# Alert Service Bulletin

## Alert Service Bulletin No. 071

### **Combustion Heater P/N CD14048 or CD14048-1 Heater Pressure Decay Test Requirement**

Figure 1 - Chieftain Heater Controls Location (early & late models)

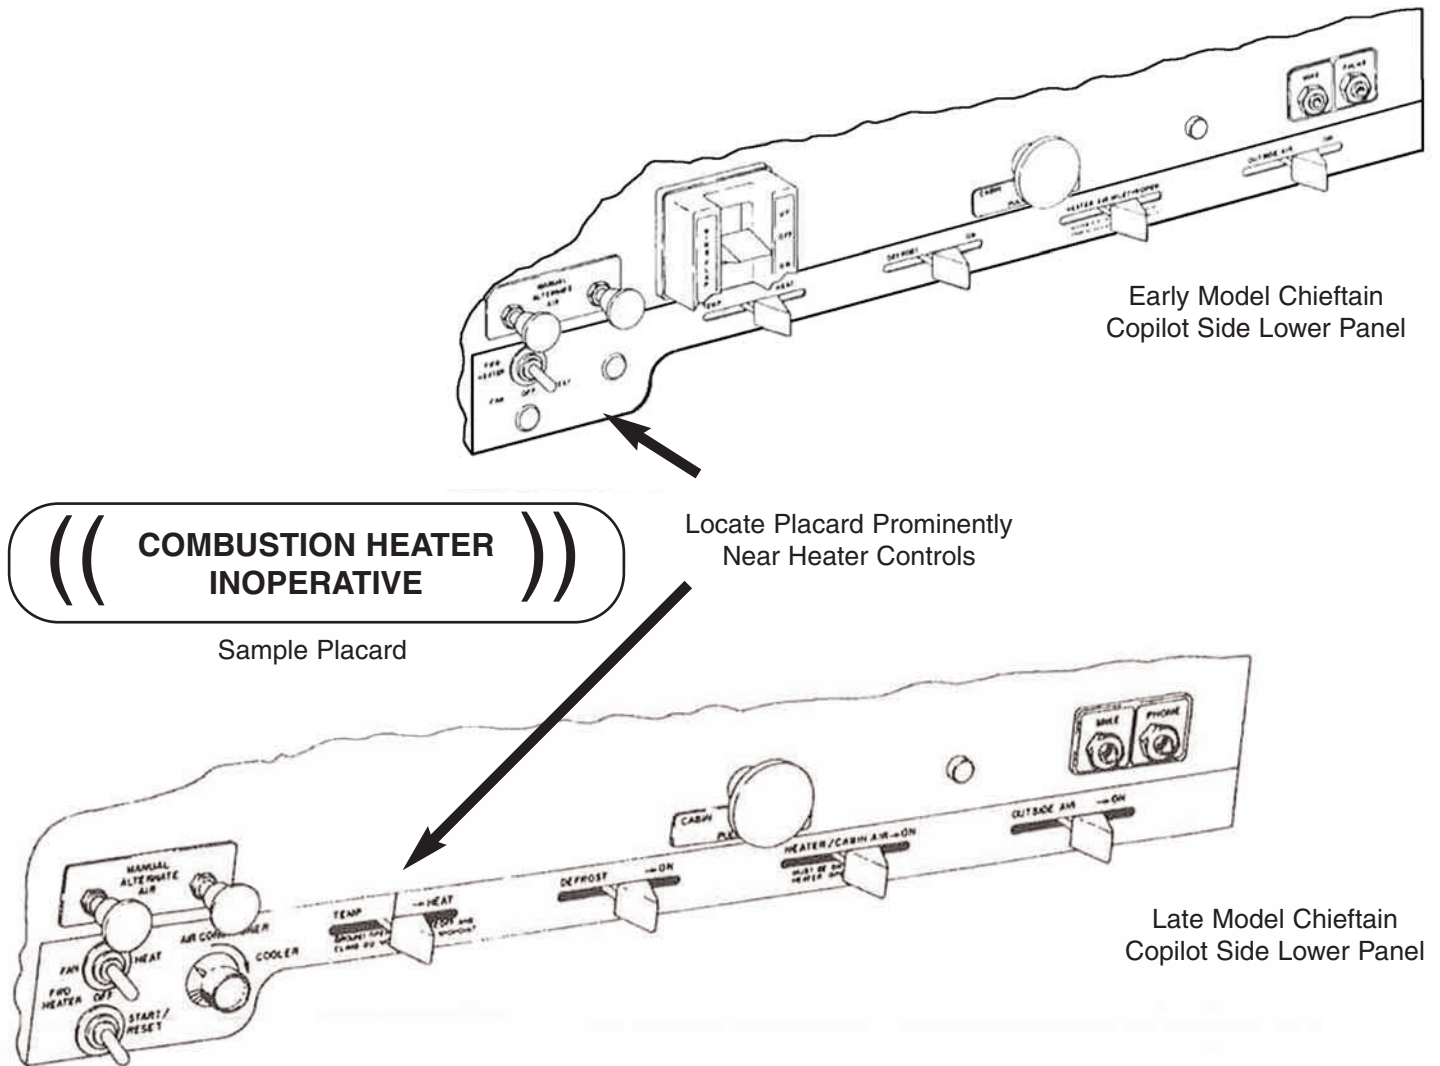
- (a) Insulate the wire terminals so the terminal is covered and it cannot contact ground potential (short). Identify and secure loose wire ends.
- (3) Locally manufacture and place a warning placard in aircraft cockpit, in the area of the combustion heater controls and at the circuit breakers. The placard should state that the combustion heater is not operational and INOP at the circuit breakers. Placards must be firmly affixed in place. (See Figs. 1 & 2)

Figure 2 - Typical Chieftain Circuit Breaker Panel

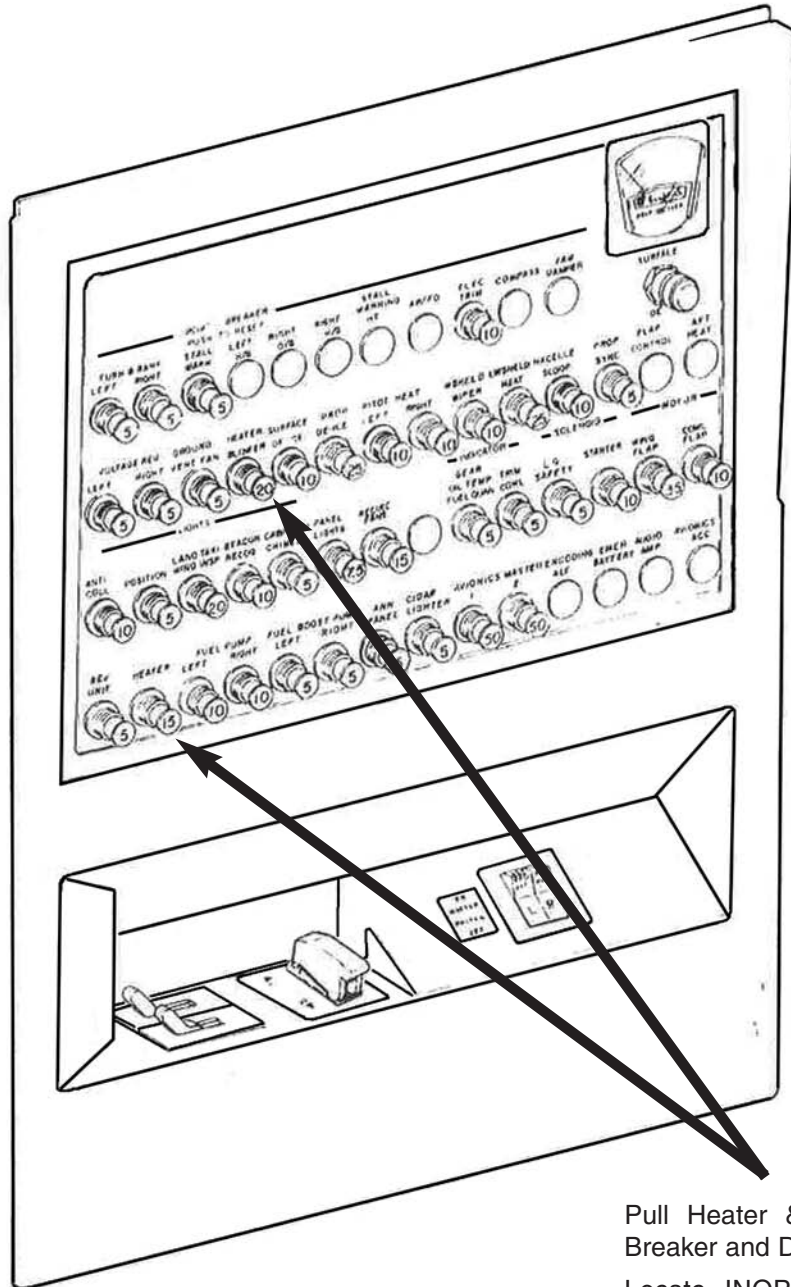
Pull Heater & Heater Blower Circuit Breaker and Disable with cable tie.

Locate INOP Placards at Heater & Heater Blower Breakers.
